UNITED STATES PATENT AND TRADEMARK OFFICE

APPLICATION NO.	FILING DATE	FIRST NAMED INVENTOR	ATTORNEY DOCKET NO.	CONFIRMATION NO.
10/737,278	12/16/2003	Tilo Dittrich	DT-6693	6177
30377	7590	11/01/2005		
DAVID TOREN, ESQ. ABELMAN FRAYNE & SCHWAB 666 THIRD AVENUE NEW YORK, NY 10017-5621			EXAMINER CHUKWURAH, NATHANIEL C	
			ART UNIT 3721	PAPER NUMBER

Office Action Summary	Application No. 10/737,278	Applicant(s) DITTRICH ET AL.	
	Examiner Nathaniel C. Chukwurah	Art Unit 3721

DETAILED ACTION

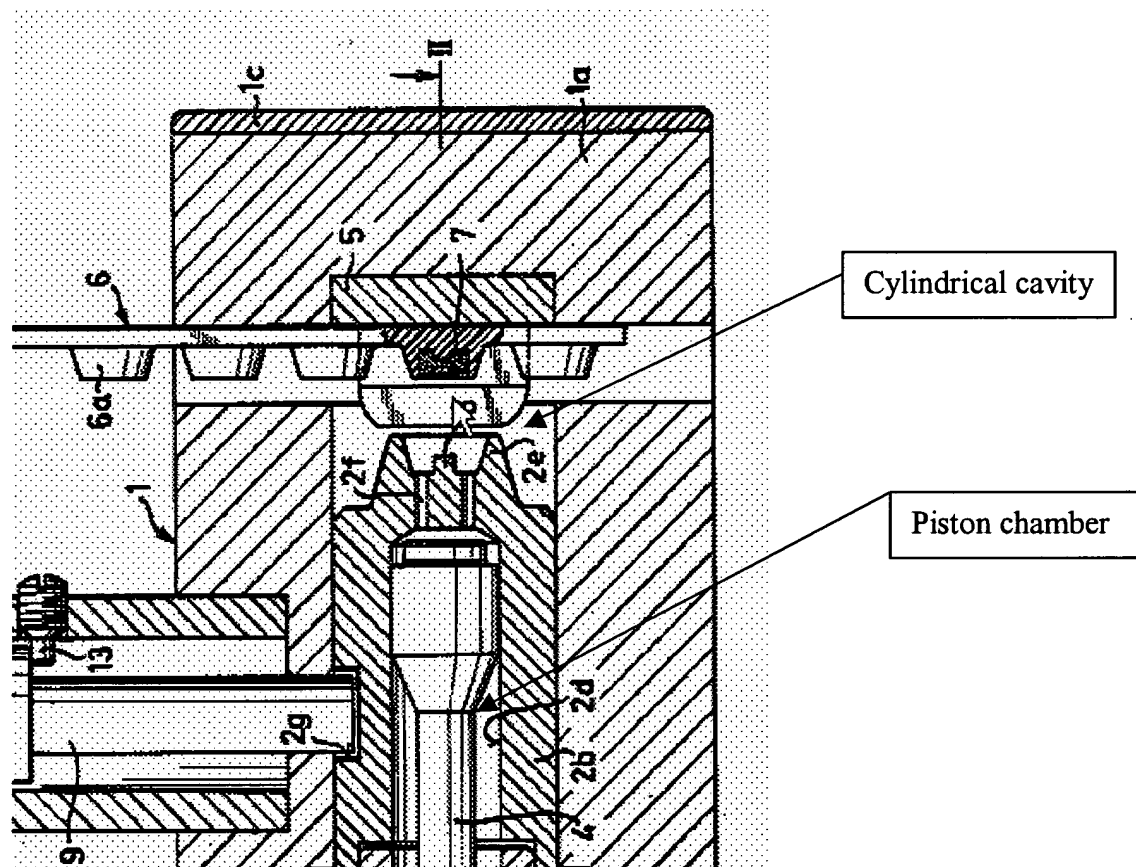
With regard to claim 1, Maier discloses an explosive-operated power tool comprising: a housing (1, 21, 41) having a cylindrical cavity (see arrow in Fig. below), and a piston chamber (see arrow in Fig. below), for receiving a drive piston (4), a breech bottom (5, 22, 42) located opposite the cavity and fixedly secured relative to the housing (1, 21, 41), a sealing sleeve (2b, 23b, 46) located in the cavity (see arrow in Fig. below) of the housing (1, 21, 41) and displaceable axially away from the breech bottom (5, 22, 42), and a cartridge (6a).

With regard to claim 2, the central axes of the cavity and the piston (4) extend at an angle to each other (see the Fig below).

With regard to claim 5, the sealing sleeve has surfaces (see arrow in Fig. below) which provide for displacement of the sealing sleeve (2b, 23b, 46) toward the breech bottom (5, 22, 42).

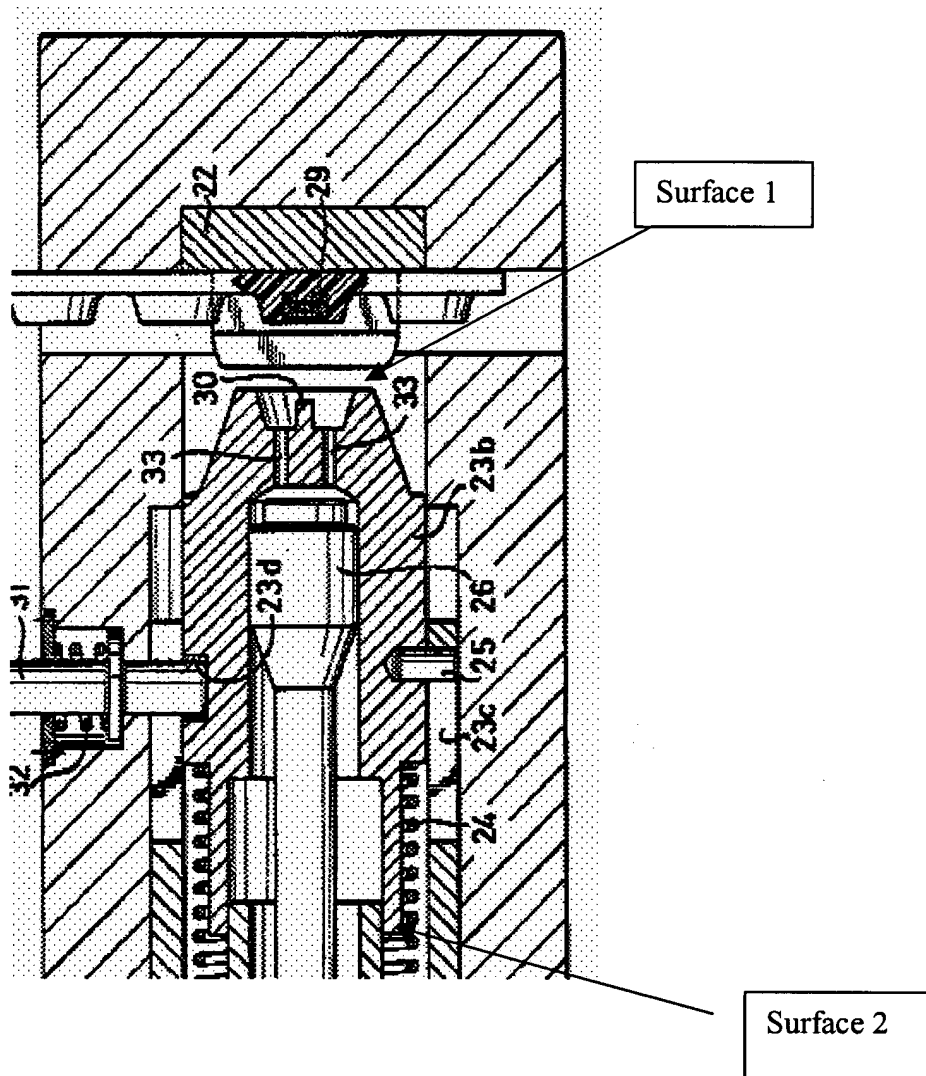
With regard to claim 6, the bottom surface of surface 2 as shown the Figure below is spaced from a bottom of the cavity when sealing sleeve receives the cartridge (6). See also Fig. 2 of Maier reference.

With regard to claim 14, Maier discloses an actuation element (2a, 23a) provided at a front end of the tool and displaceable relative to the housing (21, 41) for operating a mechanism (23a, 24) for displacing the sealing sleeve (23b, 46), the displacing mechanism displacing the sealing sleeve (23b, 46) toward and away from the breech bottom (22, 42) upon displacement of

the actuation element (2a, 23a) toward the housing (21, 41) and away from the housing , respectively.
